# Draft Loughmacask Master Plan

## Review of Traffic

Kilkenny County Council

February 2023

*Figure 2 – Roads objectives*

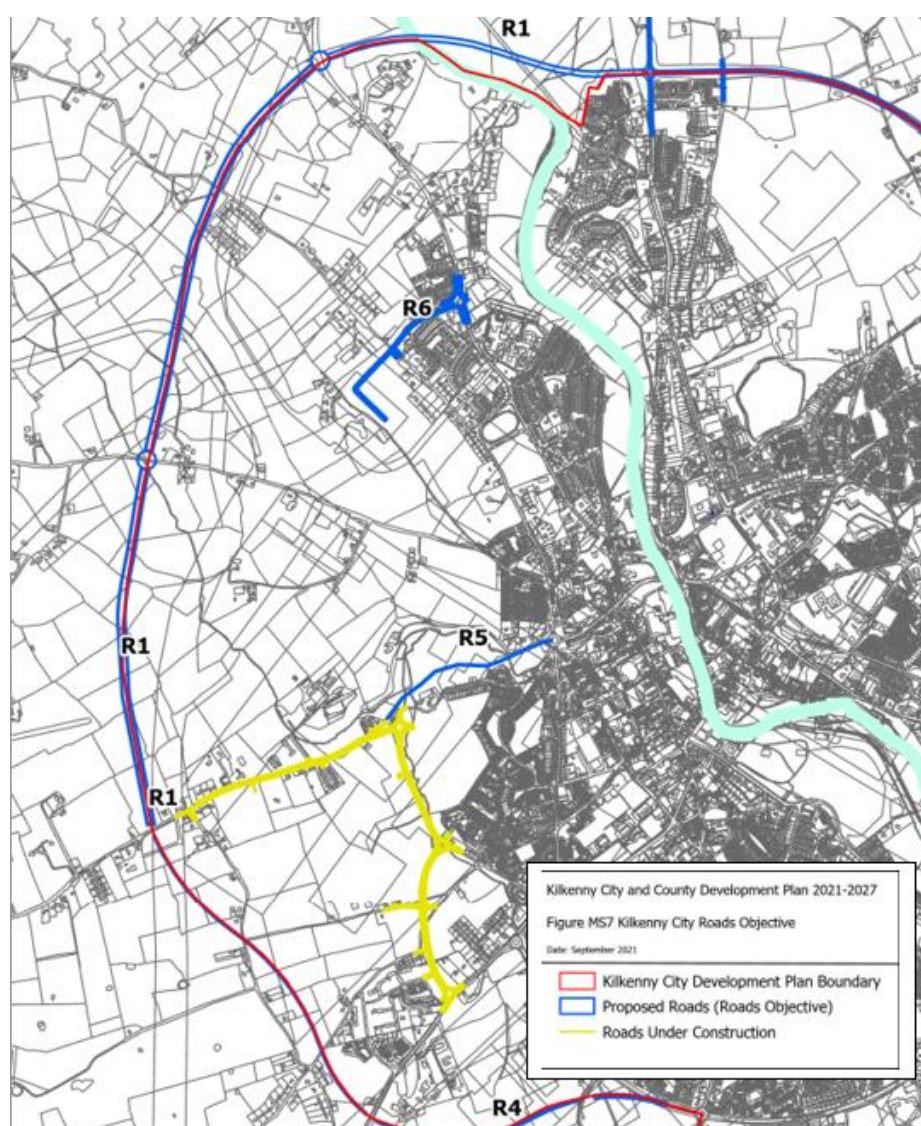
The roads objectives proposed in the area are the western bypass (R1) and the objectives R5, R6 and R7. R5 on its own would not be expected to provide any relief to the Loughmacask area. It would have a beneficial impact on Kennyswell Rd, the western environs and Dominic Stephens St. etc, but would, on its own, be unlikely to have a significant impact on the northwest of the city. R6 is shown to extend to the school from the Freshford Rd but does not extend west of the school to provide any relief for development traffic and is therefore of little consequence to a phasing plan. The western bypass and R7 are the main provisions that would give traffic relief to the existing road network in the area. The masterplan is not prescriptive in relation to the location or layout of R7 other than to say that it may be located to the west of the development zone. It is therefore not possible at this stage to differentiate between the two roads (R7 and the western bypass) in terms of their likely individual effectiveness in dealing with the issue of through traffic and both can only be considered together in respect of phasing of the development. However, it is considered that additional Masterplan development, over and above that already granted, should occur only when an orbital relief road (or part of a relief road) connecting the west and the north would be in place and would have a layout that would provide for adequate re-distribution opportunity for traffic.

- Roads R5 and R6 on their own would provide no significant traffic relief to the area. A relief road (some combination of R7 and the Western Bypass) would do so.

Figure 3-1 - Proposed Junction Upgrade on Freshford Road / Talbot's Gate Road

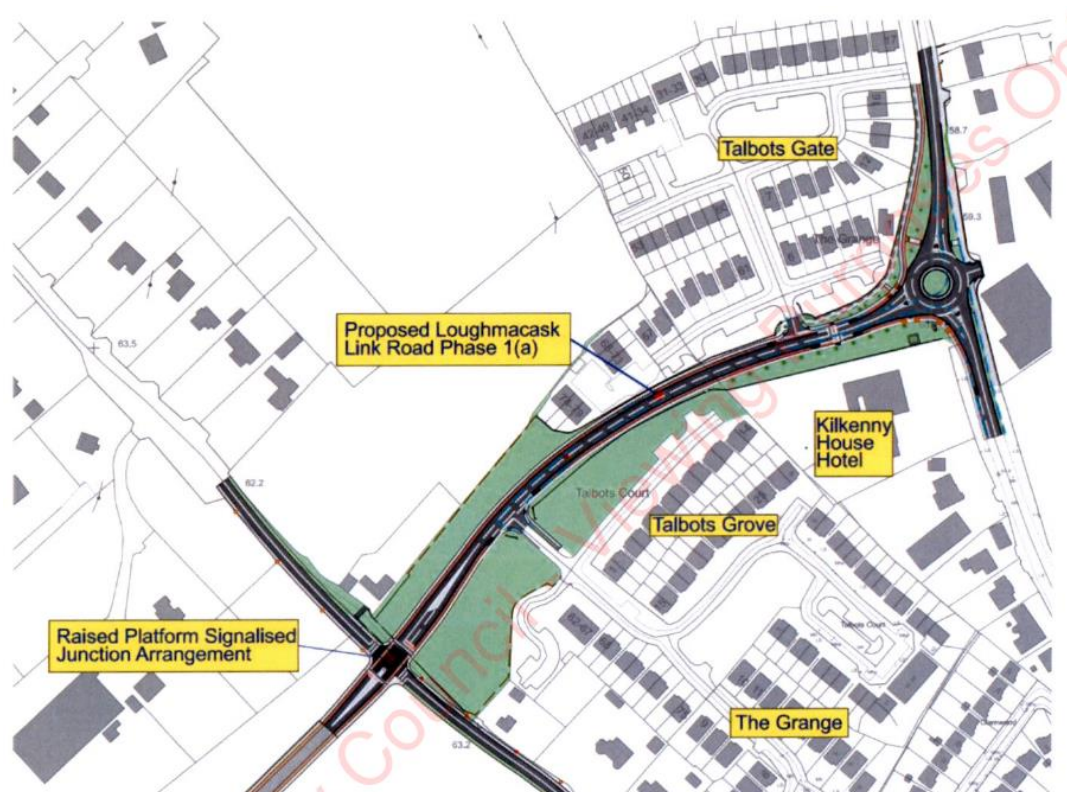
The traffic impact assessment for this development was restricted to the assessment of two junctions:

- the proposed Freshford Road / Talbot's Gate roundabout;
- the proposed Dunningstown Road / Talbot Gate Road signalised junction.

The impact on the Butts Roundabout arising from the proposal was not assessed by the TIA. The traffic impact assessment concluded that both junctions would operate acceptably with the school in place. No information is provided on predicted traffic impacts in other areas of the Masterplan.

Figure 9 – Permitted developments

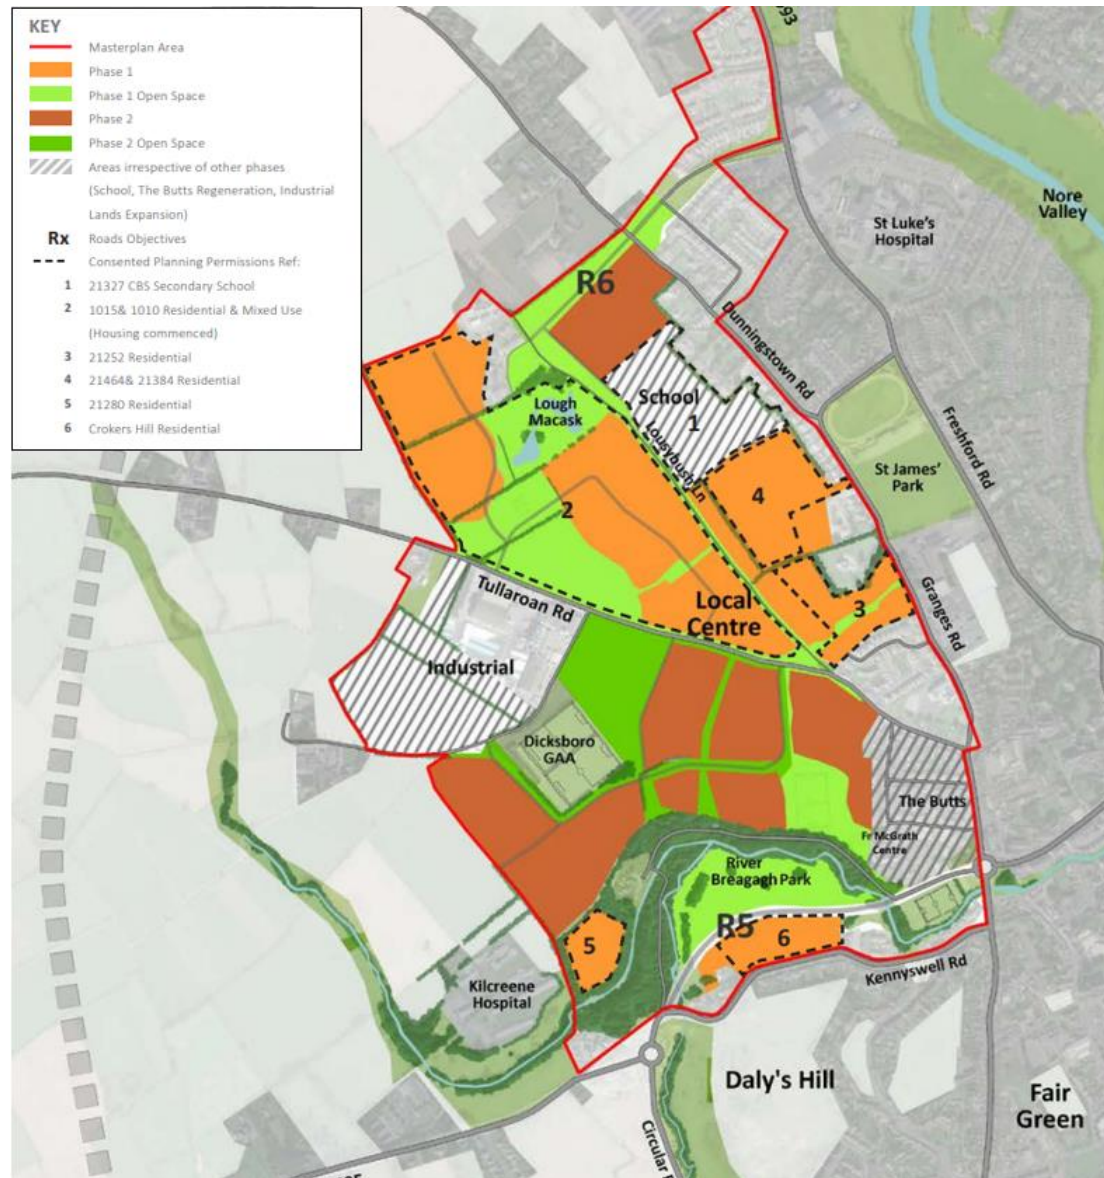
Permitted residential developments in the masterplan area total 657.

Within the Masterplan area, 657 dwellings have been granted on currently zoned residential lands and some have commenced construction, but it is understood that none are yet completed. Of the 657 granted dwellings, 340 take access onto the Tullaroan Road and the others access onto either the Granges Road or the Kennyswell Road. The new school has been granted permission and will take access off the Freshford Road.

There are 340 houses granted permission to date in Loughmacask that will access onto the Tullaroan Road (other houses for which permission has been granted take access onto other roads). Using standards generation rates for residential development such as those of the TRICS database, the number of departure vehicular trips generated by that level of development would be 170 or so during the AM peak. It is likely that peak vehicular trips would be suppressed by congestion – some drivers may choose to walk, or they may delay their trip to an off-peak time; however for many people there may be no choice but to travel by vehicle during the peak. The level of peak spreading and modal shift that would occur as drivers respond to increased congestion is uncertain, particularly in the context of recently increased working-from-home, but if the number of inbound vehicles were 110 (rather than 170), the maximum queue during the am peak would extend by 660m length on Lord Edward Street / Tullaroan Road (an increase from the maximum observed queue of 90m or so). Longer queues are experienced elsewhere in the city - such as on the Carlow Road during the AM - but the change in the queue length and delay length on the Tullaroan Road would be significant.

*Figure 15 - Pedestrians crossing Butts Roundabout*

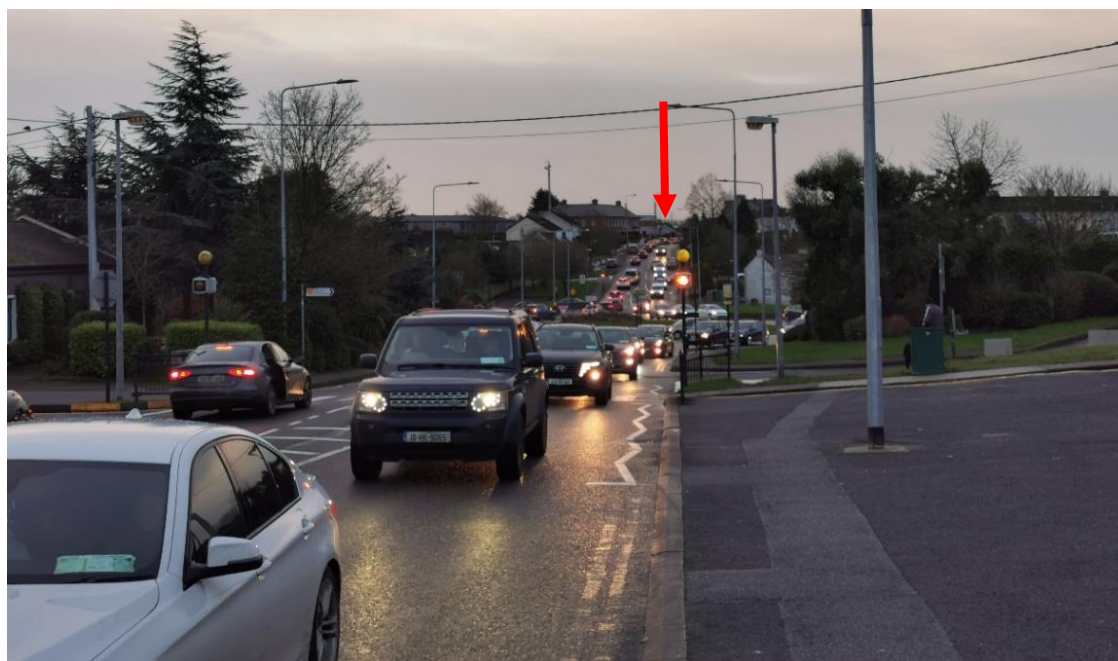
- There is a clear need for pedestrian facilities across the arms of the Butts Roundabout. Pedestrians were seen to find it very difficult to cross the junction.

Making Butts Roundabout Pedestrian Friendly. The walking route to the CBS from the south will be via Lord Edward Street and Lousybush lane. Some schoolchildren are likely to cross at the roundabout and there are no facilities there at present. Insertion of improved pedestrian facilities and new pedestrian crossings are urgently needed, but they could reduce vehicular traffic capacity – see Figure 15.
